Redline Markups

2023 City of Seattle Standard Plans for Municipal Construction

The Standard Plans shown here depict the proposed edits of the 2020 Standard Plans used to create the 2023 Construction Standards.

SECTION A–A

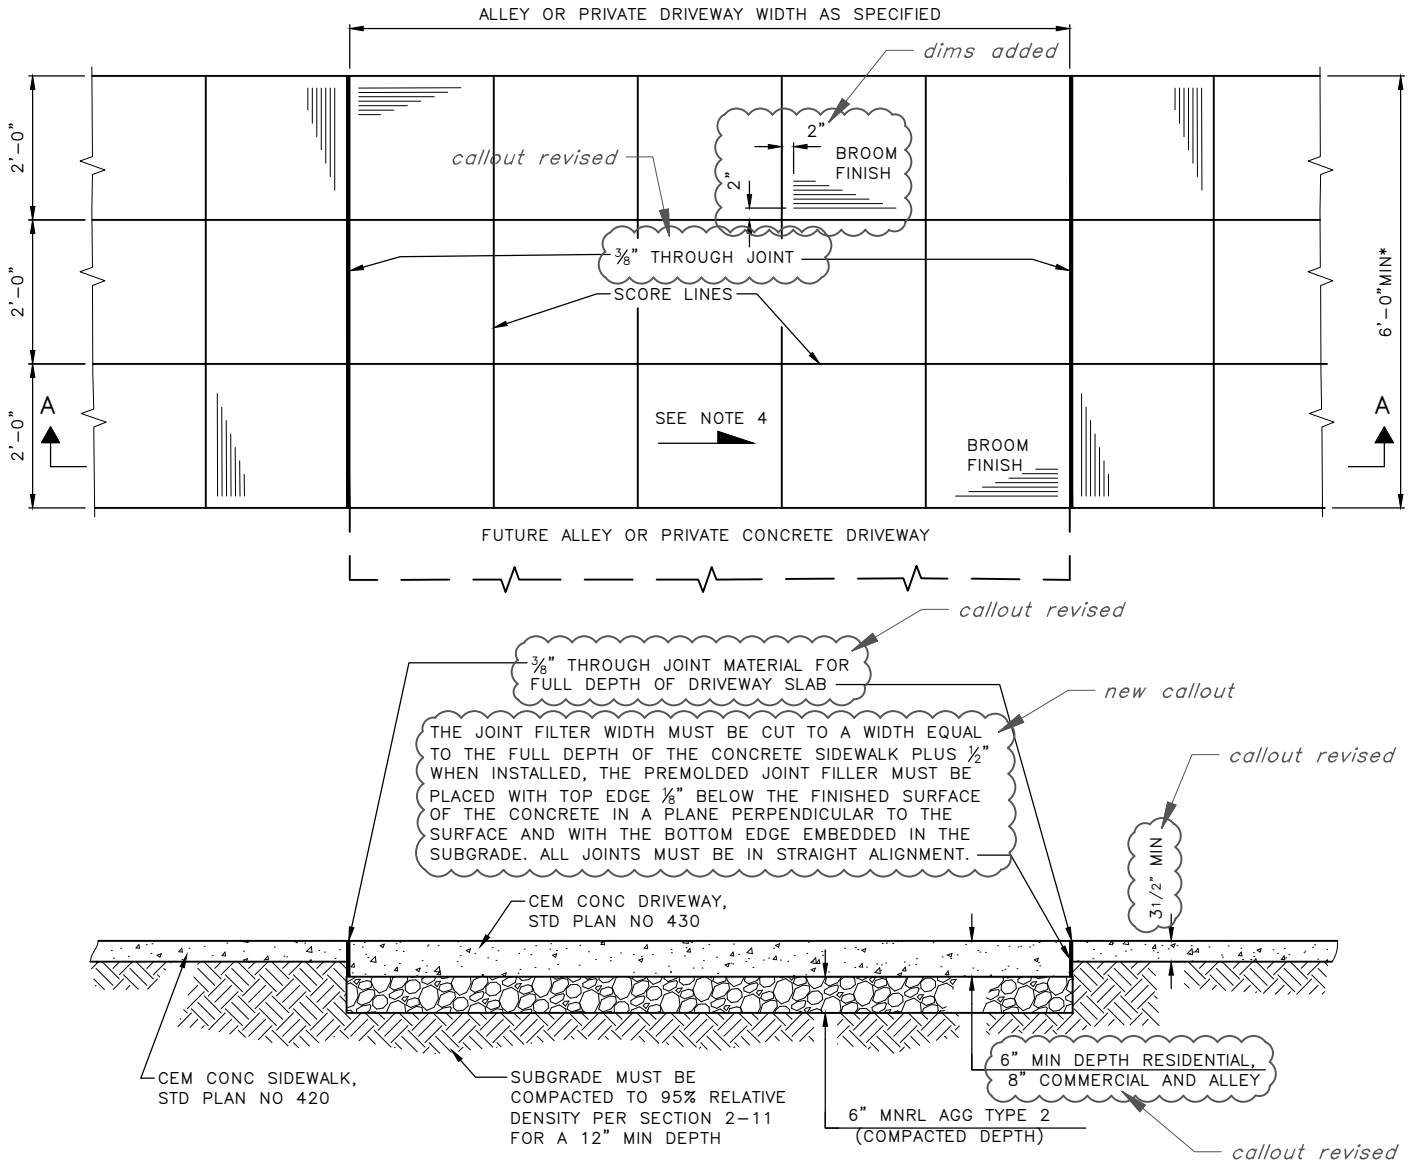
notes 1 & 2 revised

1. DRIVEWAY WIDTH GREATER THAN 15'–0" MUST HAVE ⅜" TRANSVERSE CONTRACTION JOINT AT OR NEAR ITS CENTER.
2. DRIVEWAY GREATER THAN 30'–0" REQUIRES APPROVAL. SET ⅜" TRANSVERSE CONTRACTION JOINTS AT INTERVALS OF 8' TO 15', UNLESS OTHERWISE SPECIFIED.
3. PROVIDE SCORE LINES PER STD PLAN NO 420 AND THE DRAWINGS.
4. THE SURFACE MUST BE BRUSHED IN THE TRANSVERSE DIRECTION IN RELATION TO THE CENTERLINE OF THE DRIVEWAY OR ALLEY WITH A FIBER HAIR BRUSH OR OTHER APPROVED BRUSH TYPE.
5. PROTECT ADJACENT PANELS FROM DAMAGE DUE TO UNDERMINING DURING EXCAVATION & PLACEMENT OF SUBGRADE. SEE SPEC SECTION 1–07.13.

City of Seattle	NOT TO SCALE	STREET LIGHT POLE FOUNDATIONS

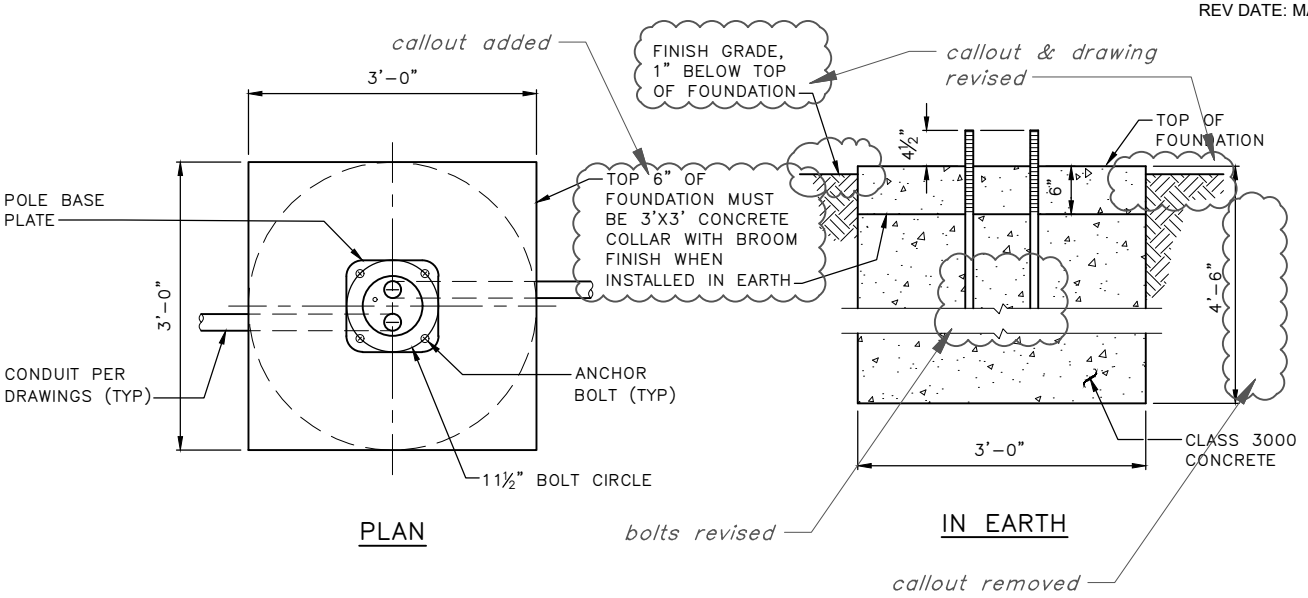
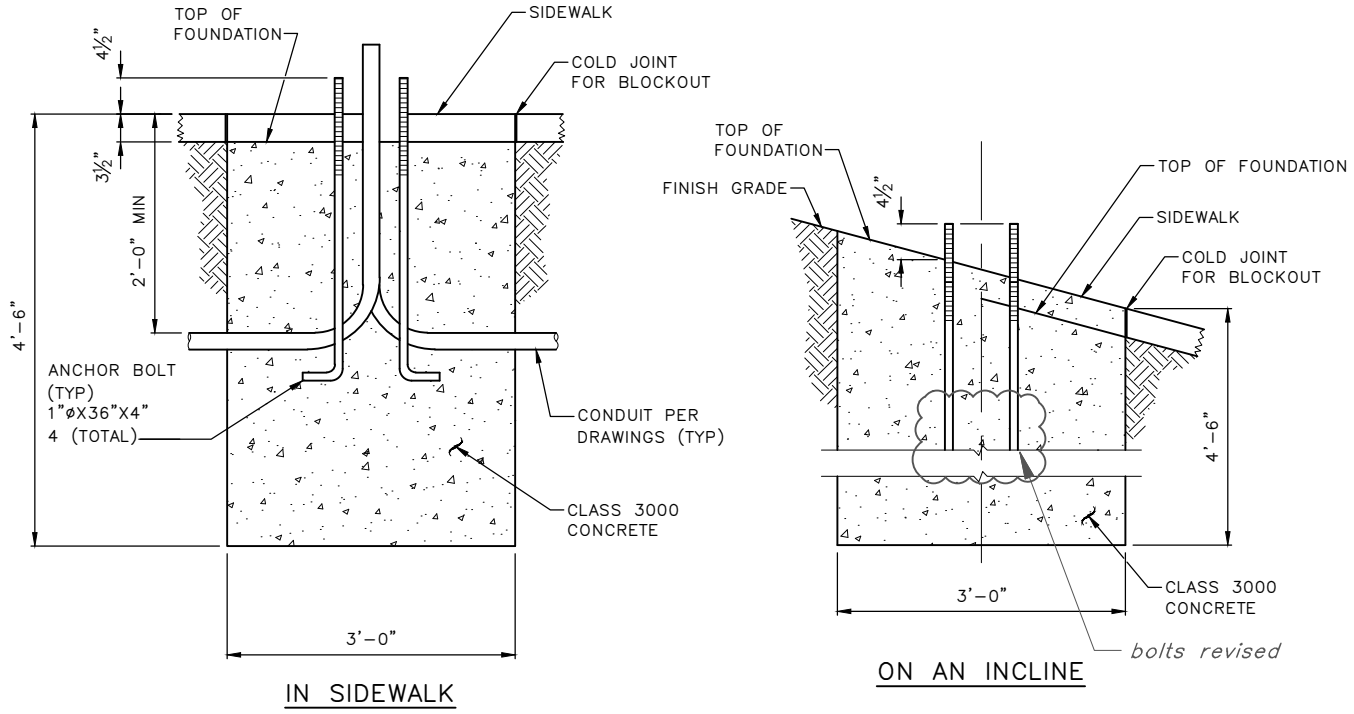
former note 1 removed

note added

1. SEE SCL CONSTRUCTION STANDARD 1716.34 FOR POLE MOUNTING AND GROUT DETAIL
2. ANCHOR BOLTS MUST BE HOT DIP GALVANIZED ASTM A153 OR F2329, FULL LENGTH AND FABRICATED FROM ASTM F1554 OR A576 WITH 12" THREADS ON TOP
3. ALL SHRUBBERY AND FOLIAGE MUST BE PLANTED A MINIMUM OF 2' FROM SCL STRUCTURE PER SCL CONSTRUCTION STANDARD 0214.00

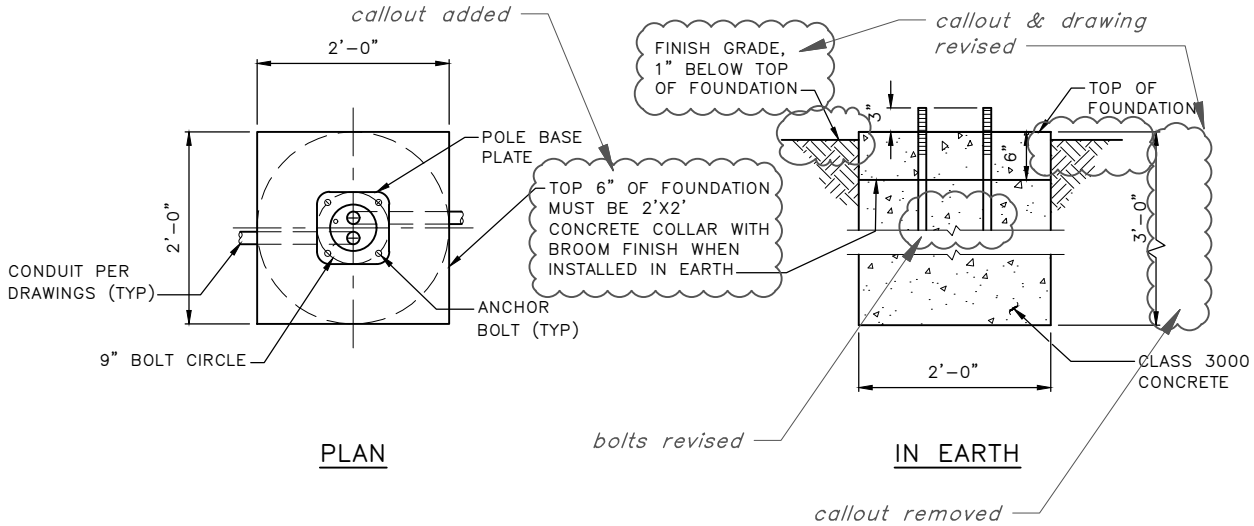
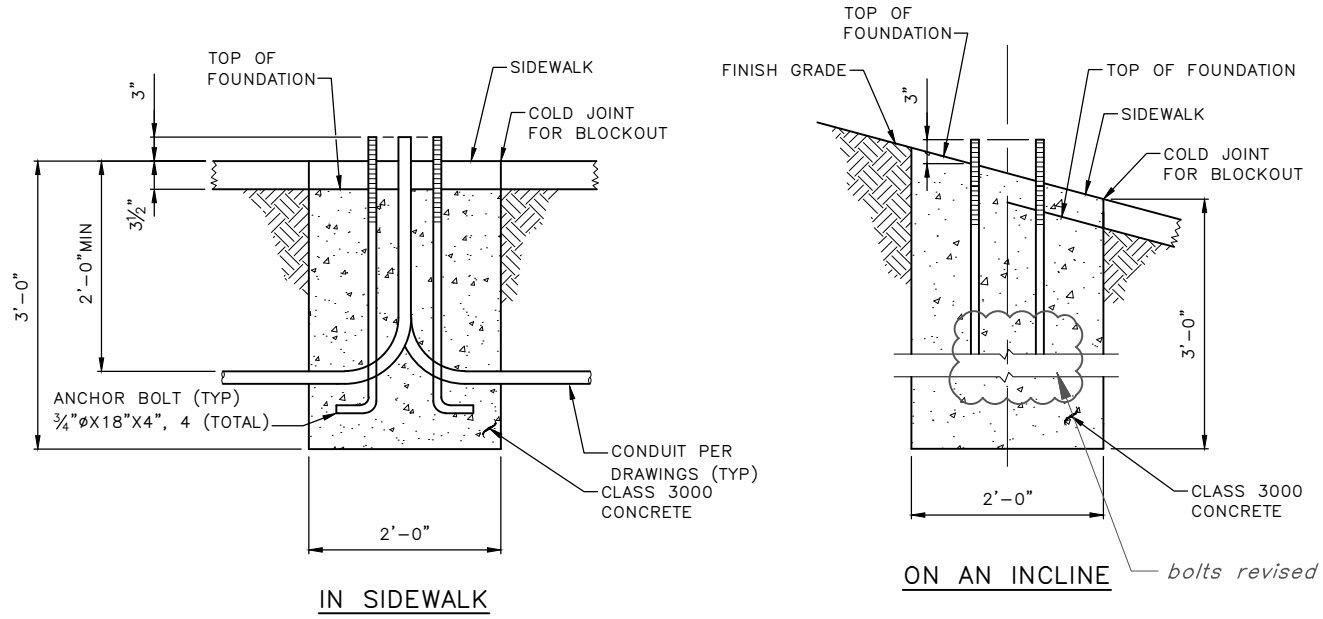
former note 1 removed

note added

1. SEE SCL CONSTRUCTION STANDARD 1716.34 FOR POLE MOUNTING AND GROUT DETAIL
2. ANCHOR BOLTS MUST BE HOT DIP GALVANIZED TO ASTM A153 OR F2329, FULL LENGTH AND FABRICATED FROM ASTM F1554 OR A576 WITH 8" OF THREADS ON TOP
3. SEE SCL MATERIAL STANDARD 5756.09 FOR POLES
4. SEE SCL CONSTRUCTION STANDARD 1716.07 FOR STREETLIGHT HANDHOLE AND CONDUIT REQUIREMENTS.

5. ALL SHRUBBERY AND FOLIAGE MUST BE PLANTED A MINIMUM OF 2' FROM SCL STRUCTURE PER SCL CONSTRUCTION STANDARD 0214.00

TYPICAL CURBSIDE RED BUS LANE LAYOUT

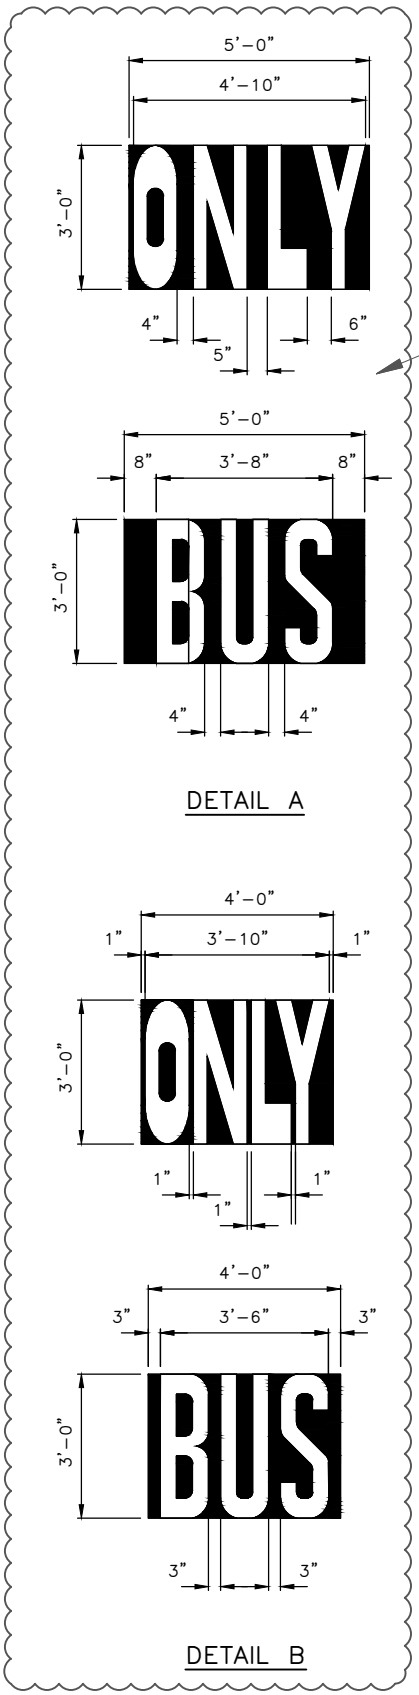
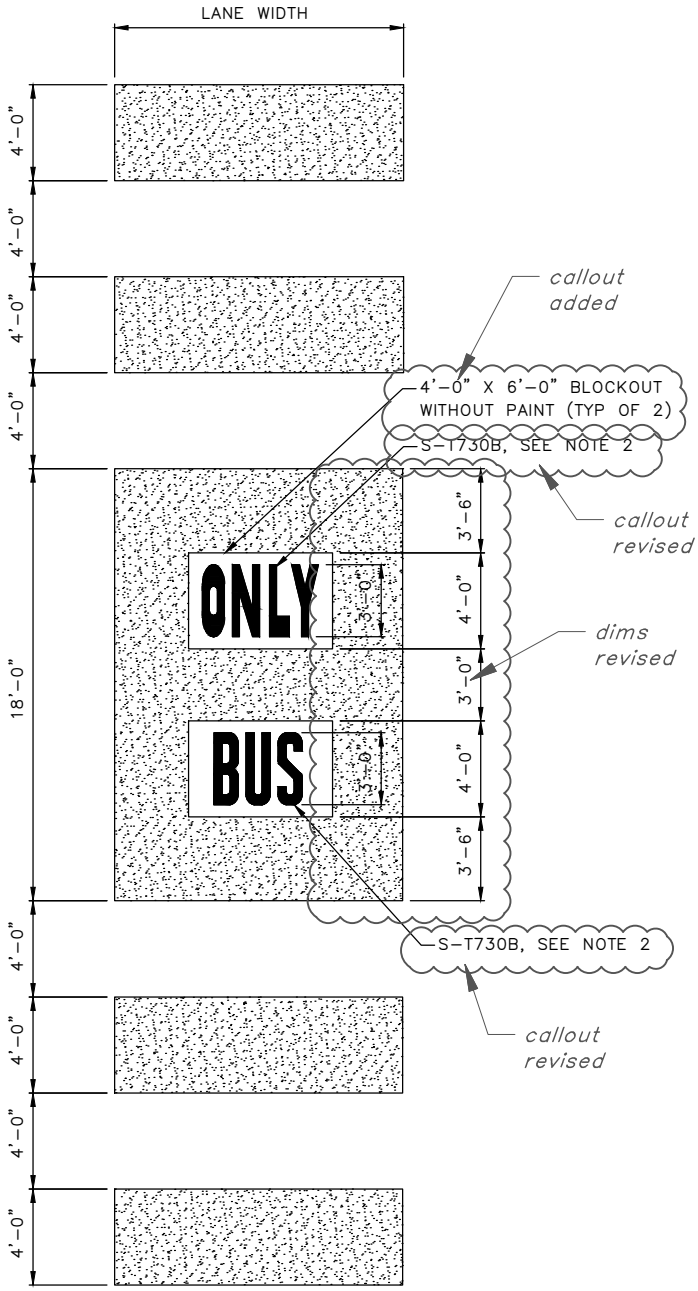
details added

callout added

callout revised

dims revised

callout revised

note 1 revised, note 2 added

1. FHWA APPROVED RED COLOR FOR BUS LANES MUST BE USED WITH MMA.
2. FOR APPLICATION ON CEM CONC PVMT, LEGENDS PER STANDARD PLAN 730 MUST HAVE A 5'–0" X 3'–0" COLOR BLACK THERMOPLASTIC BACKGROUND PER DETAIL A. FOR APPLICATION ON CEM CONC PVMT IN A STREET CAR TRACK, LEGENDS PER STANDARD PLAN 730 MUST HAVE A 4'–0" X 3'–0" COLOR BLACK THERMOPLASTIC BACKGROUND PER DETAIL B. PROVIDE 6" MINIMUM GAP BETWEEN THERMO LEGENDS AND RED MMA.
